# Product Change Notification

**Change Notification #:** 115305-00  
**Change Title:** Intel® Compute Module HNS2600KPR  
PCN115306-00, Product Material,  
Replacement of BMC DDR3 chip  
**Date of Publication:** February 15, 2017

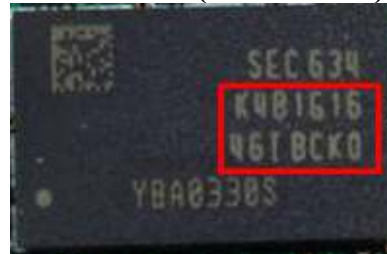
Intel is replacing the current BMC DDR3 memory chip K4B1G1646G-BCH9 (G38649-001) (end of life) with new K4B1G1646I-BCK0 (J37656-001). Intel reports validation completed with passing results. The replacement component is identical in form, fit and function.

**Current DDR3 (G38649-001)**

**New DDR3 (J37656-001)**
